Re: Mossbrook Estates

POADP # 652

The City Staff Development Review Committee has reviewed Mossbrook Estates Preliminary Overall Area Development Plan # 652. Please find enclosed a signed copy for your files. Although your plan was accepted, please note the following:

P.O.A.D.P. PLAN
for
MOSSBROOK ESTATES

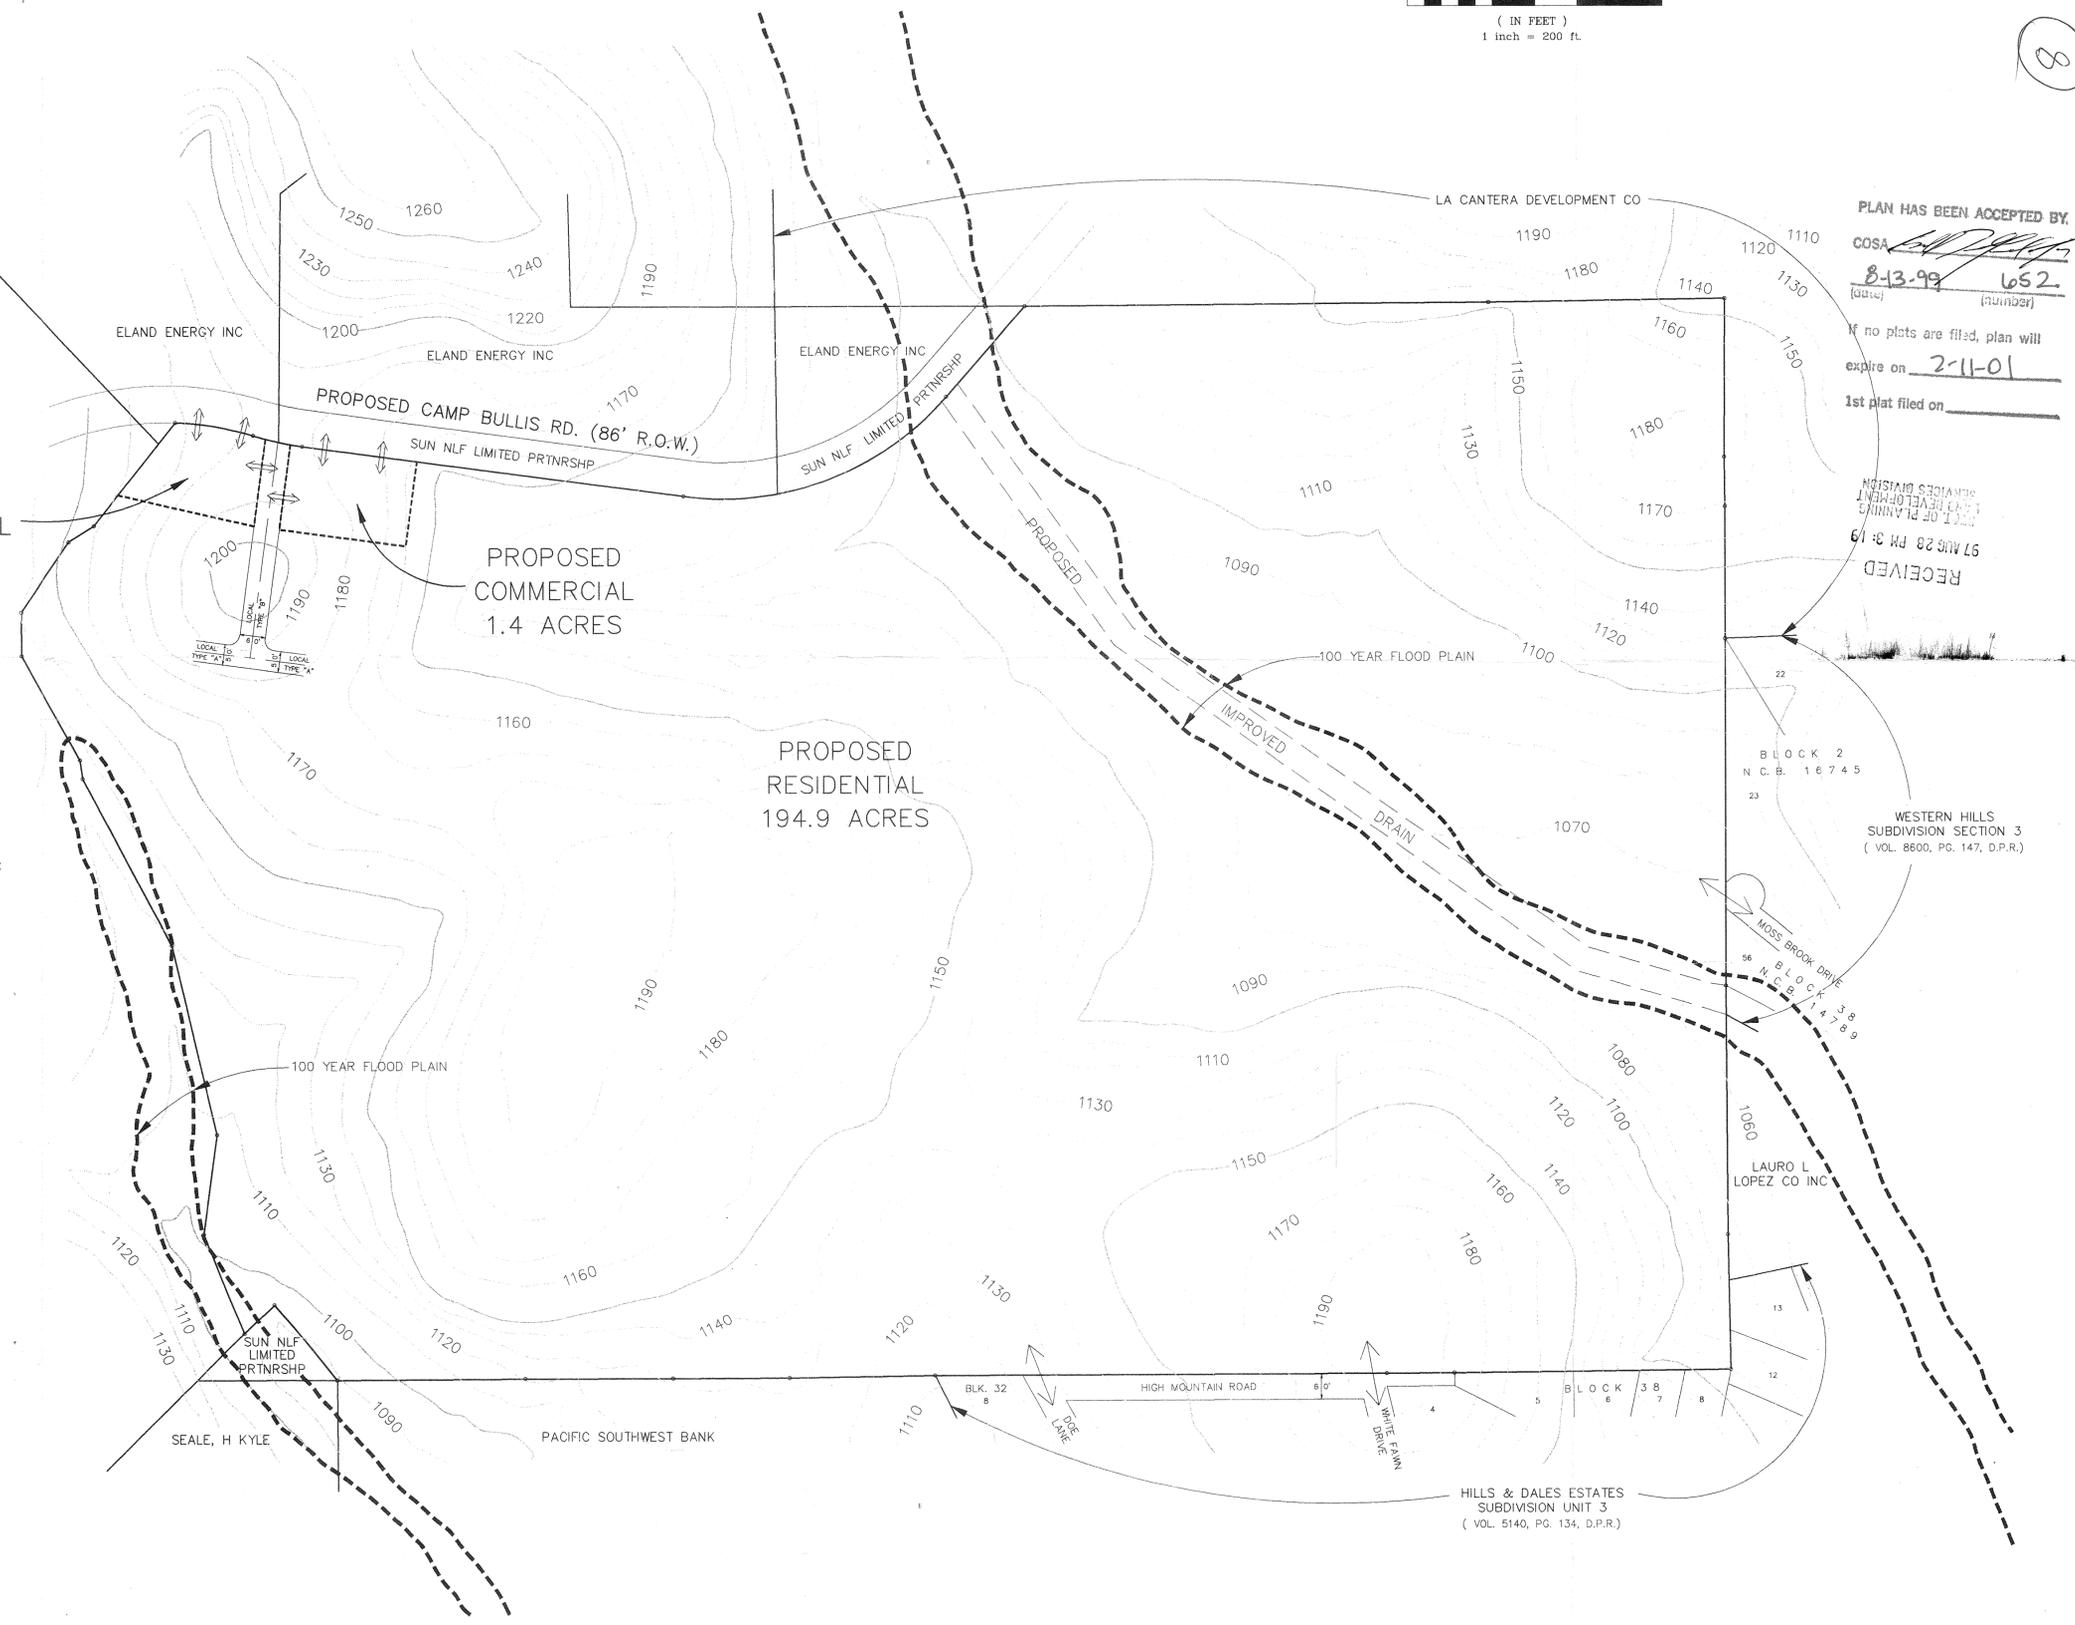
- Based on the topography, a Flood Plain Study and drainage review will probably be required during the platting process.
- In consideration of public safety and convenience, excessive grades by reason of topography should be avoided in street layouts and arrangements.

- This development will probably need to conform to requirements associated with development over the Edwards Aquifer. For additional information about these requirements you can contact SAWS at 704-7305.

- Access and R.O.W. issues along State facilities will need to be resolved with the Texas Department of Transportation (TXDOT). For information about these requirements you can contact TXDOT at 615-5814.

- This development will need to comply with tree preservation ordinance #85262. For information about these requirements you can contact Building Inspections at 207-7102.

- It will be expected that you will plat all of the property depicted in your POADP, to include: floodpains, drainage areas and open space.
- I would encourage you to work closely with the school district, so that they can plan accordingly.
